AGENDA
CITY OF GLENWOOD SPRINGS
REGULAR CITY COUNCIL MEETING
MAY 2, 2019
101 W. 8TH STREET
6:15 PM

6:55pm	11. Planning Item #01-19 - Consideration of a Major Site/Architectural Plan Review for a Multi-Tenant Office/Retail Building, Lot 14 Glenwood Meadows No. 2, Wulfsohn Road		Discussion and/or Action

SHEET TITLE
ARCHITECTURAL SITE PLAN

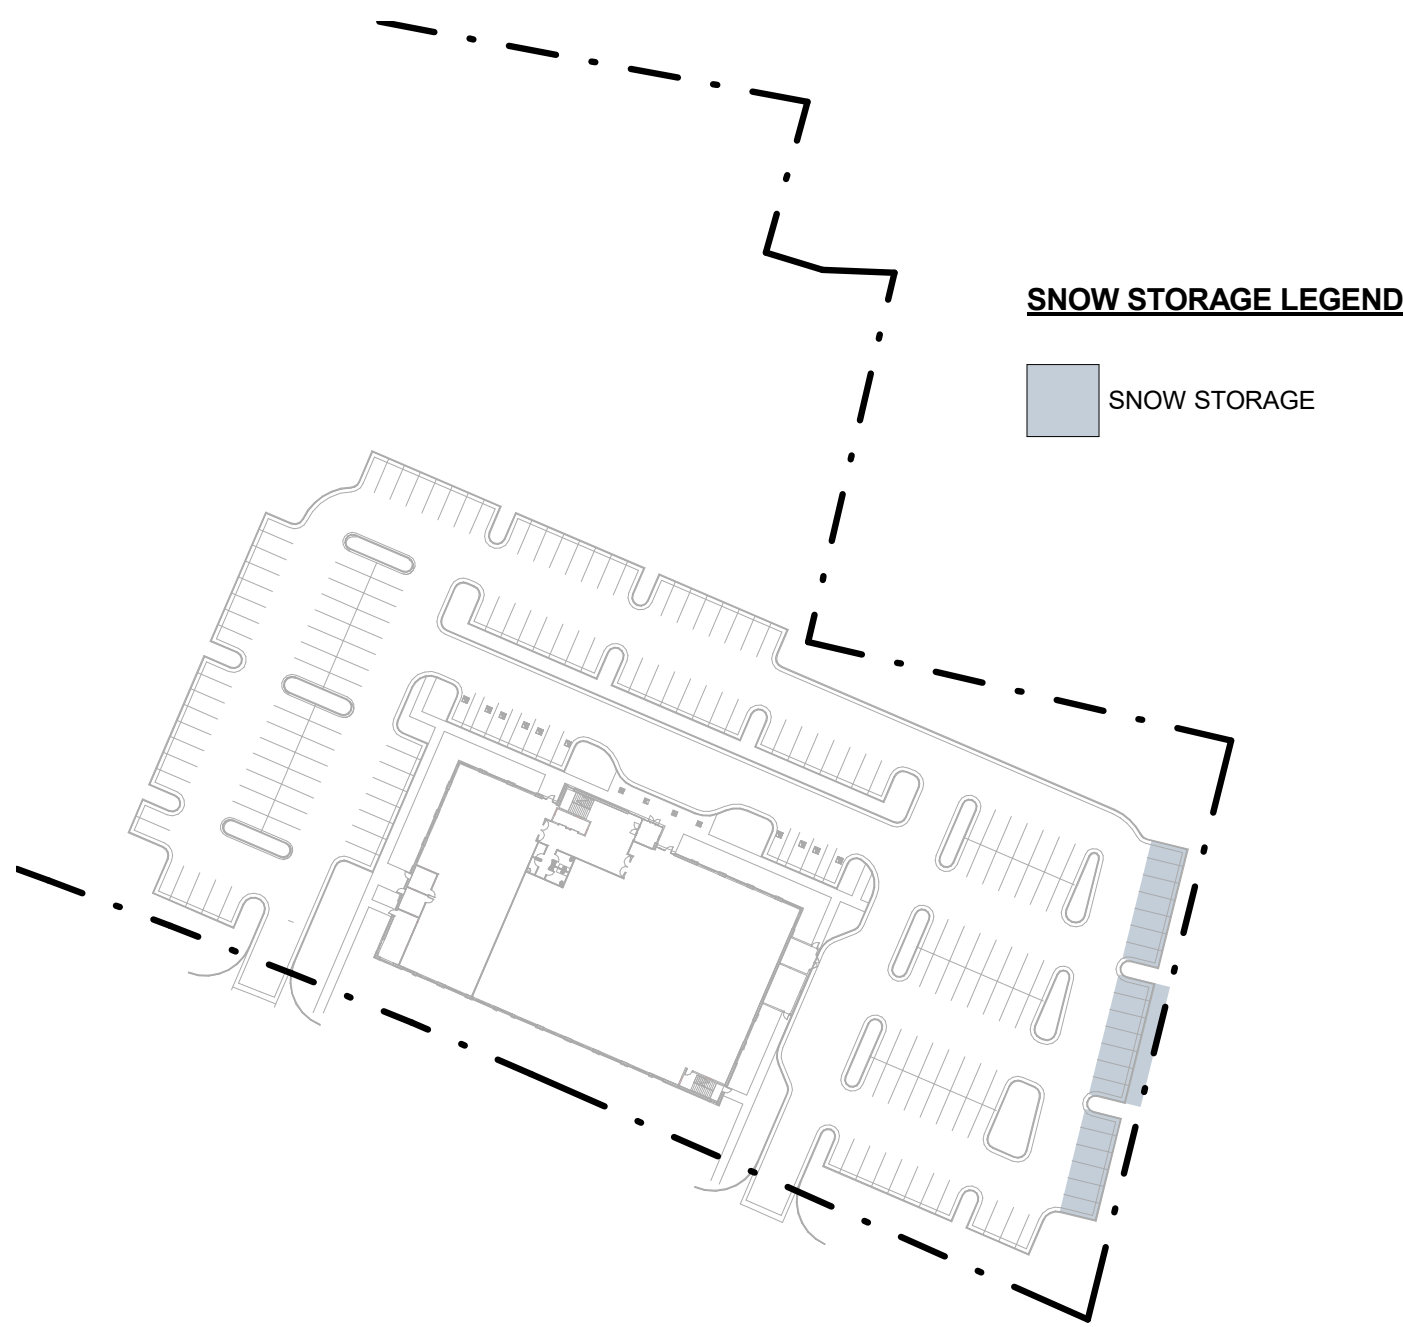
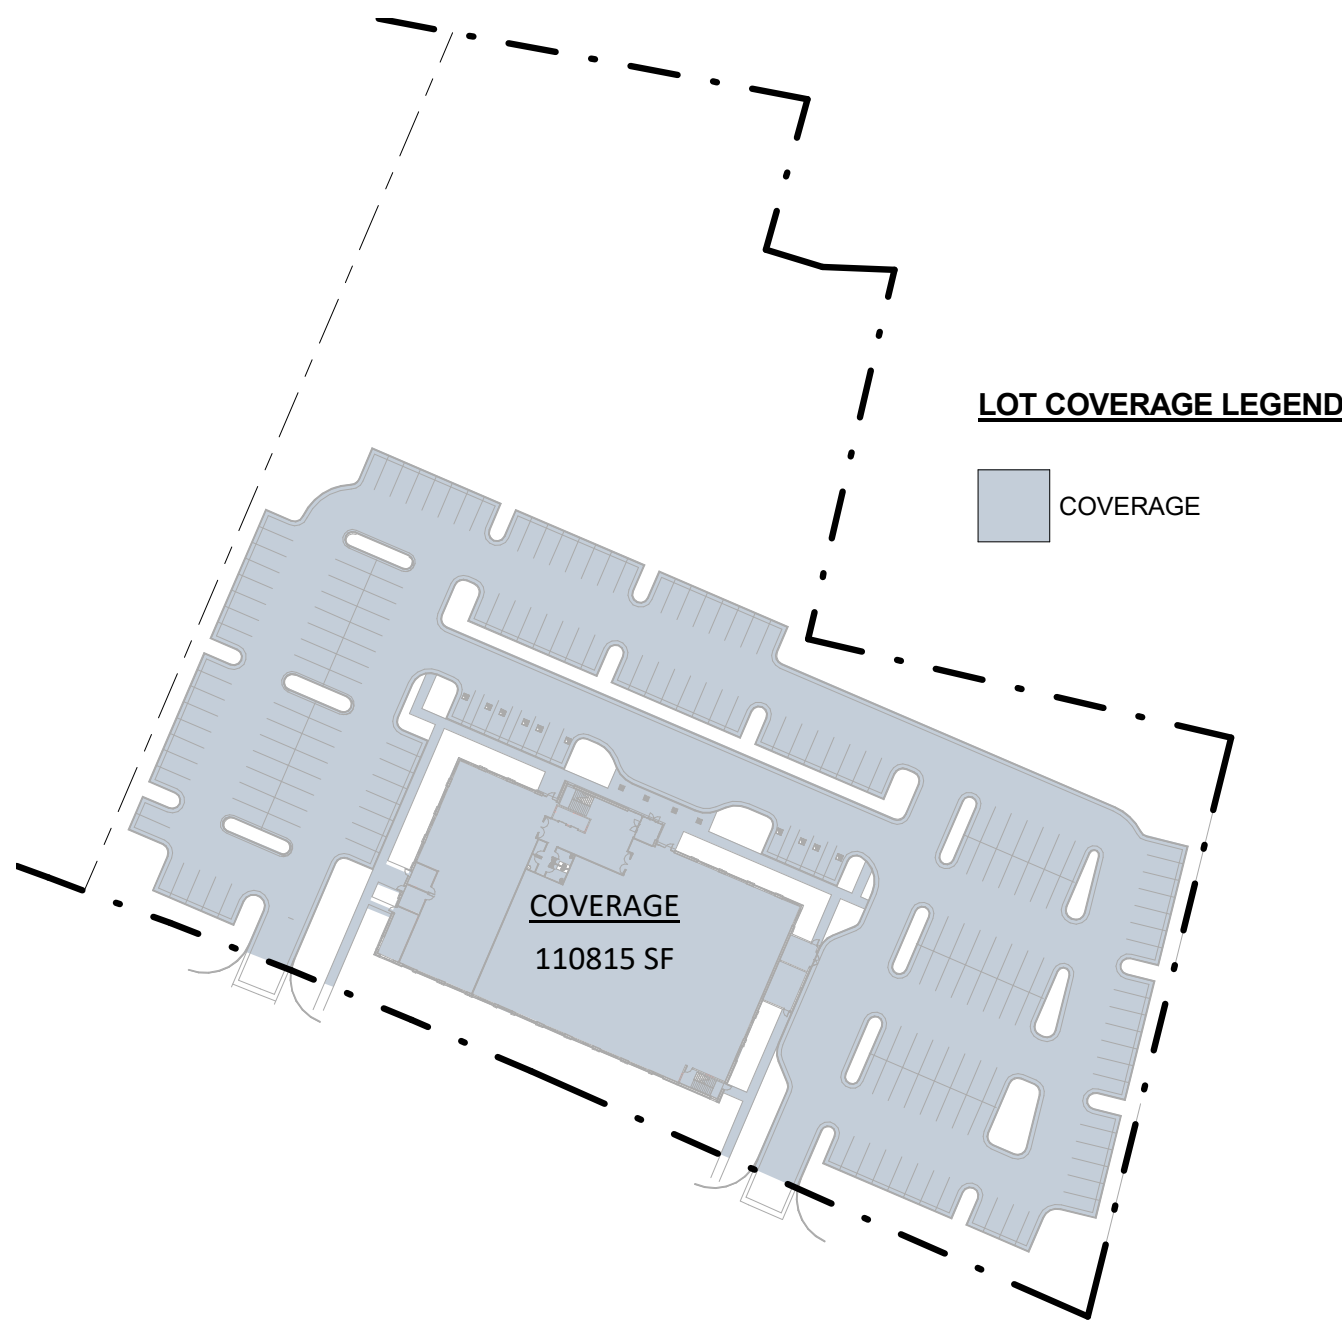
- Please provide pedestrian access to from the parking area to the primary entrance of the building. See sheet A101 of the revised plan set
- Please revise the retaining wall heights to an average height of six feet and not to exceed 10 feet at any point. See Boulder letter dated 3/8/19, Pg. 1, #3 in Green

- Please call out building dimensions on the site plan. See sheet A201/202
- Please clarify the number of required and provided parking spaces on various sheets. See sheet A101

- Please call out parking aisle widths and parking stalls from the end of each stall. See sheet A101
- Please call ouf the maximum height of the building on each elevation.

2. The M1 zone district requires that landscaping make up a minimum of 15 percent of the site and it appears you provide only 8.9 percent.
 - *The landscaped area requirement was calculated from the limit of disturbance area of 149,200 sqft located on sheet L100 providing us with 26% landscaped area. We used this calculation to isolate a square footage based on this specific project area within the overall site with the intent that future development on the site will account for the remaining required landscape for each development.*

See sheet A101 of the revised plan set

See sheet A101 of the revised plan set

PLEASE SEE THE REVISED CALCULATIONS REFLECTING THE DEVELOPED AREA (LIMITS OF DISTURBANCE)

- Please see the revised table on Sheet A-101 providing the calculations using the proposed developed area (Limits of Disturbance).
- 3. It seems the plans lack internal pedestrian access from parking areas to the building entrance(s).

A-301

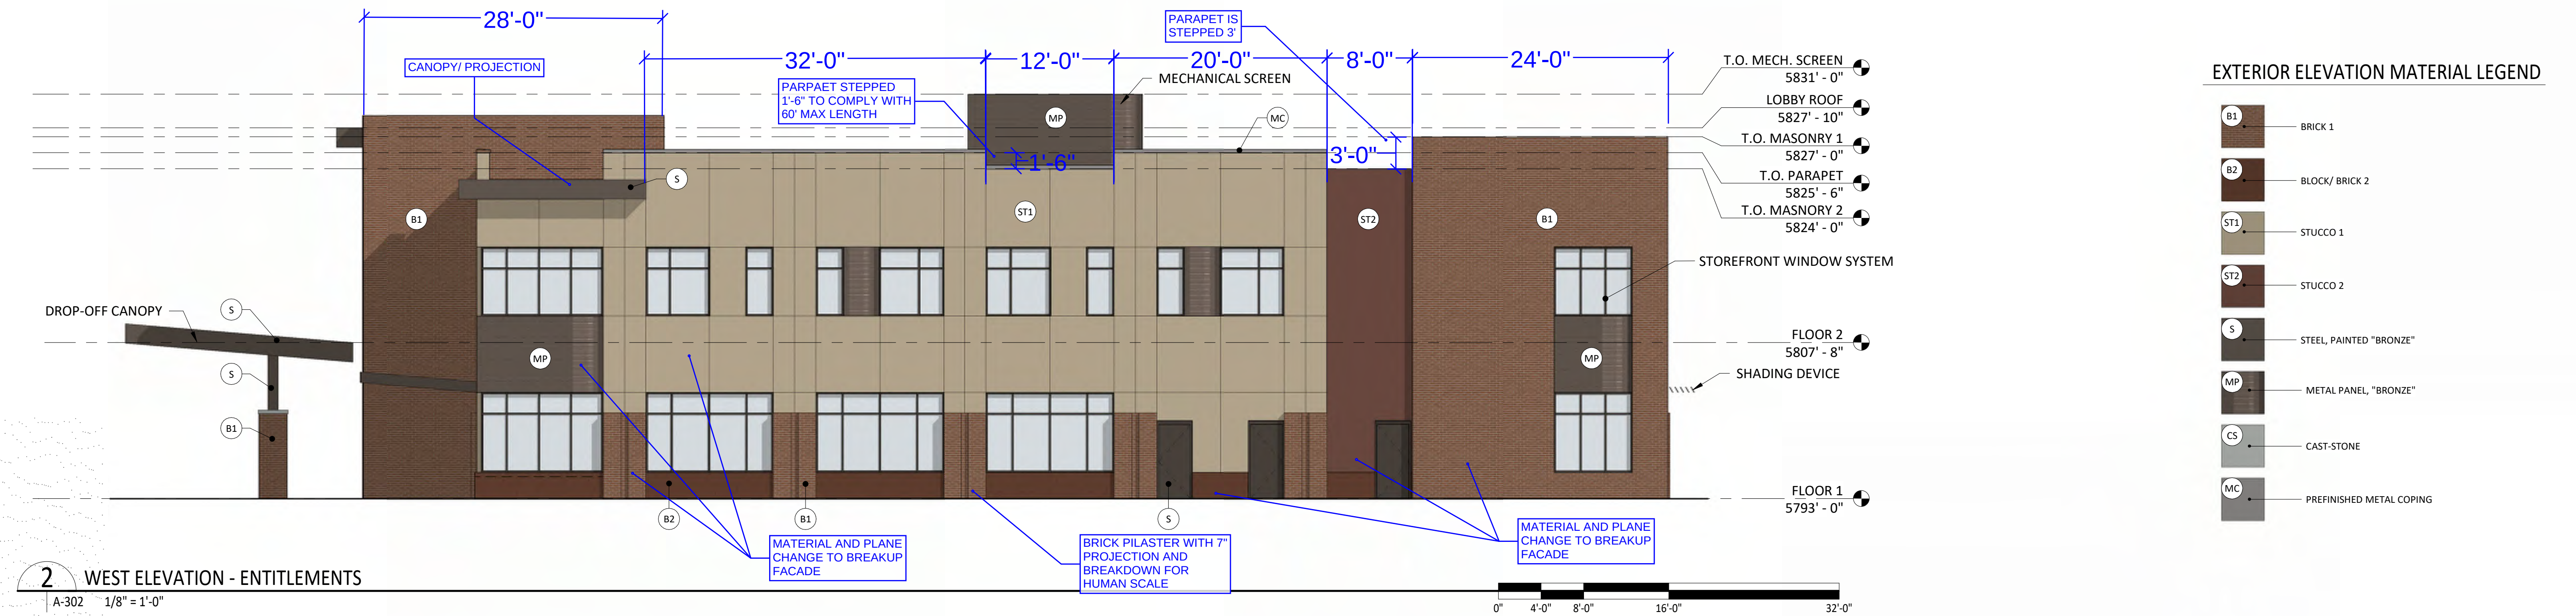
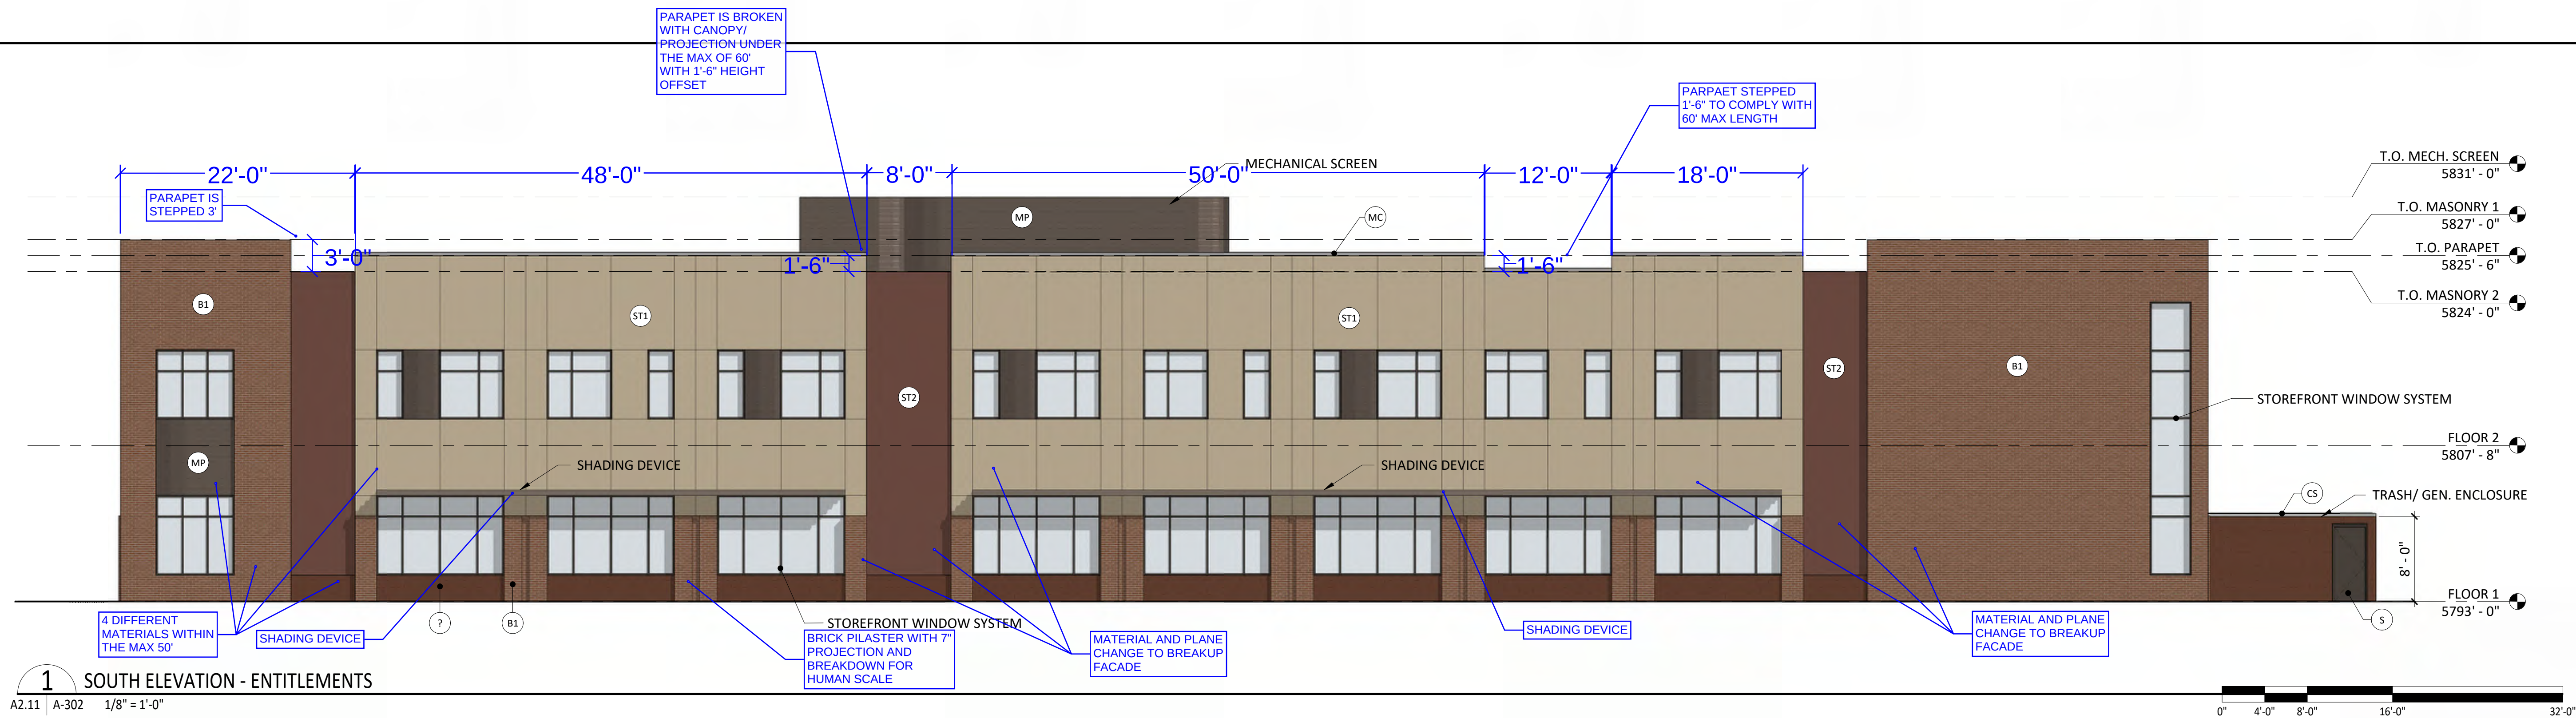
- Please revise or provide detail depicting 60 percent coverage by windows, awnings, or other architectural elements along th south elevation0. See sheet A301 & A302 of the revised plan set

6. It does not appear (per sheet A-302) you provide a building entrance on the south elevation which faces the principal street providing access to the site. That being said, the preliminary site plan (but not architectural site plan) appears to show sidewalk connections to this side of the building. Please clarify.

- Please refer to the added table on Sheet A-301 Exterior Elevations and A-302 Exterior Elevations (Exhibit) indicating the proportions along 60% of the horizontal length.

- *Please refer to Sheet A-301 Exterior Elevations and A-302 Exterior Elevations (Exhibit) identifying the stepping of the parapets in compliance with this section. We have either stepped or provided a roof projection to the roof/ parapets to be less than the max 60' in length.*
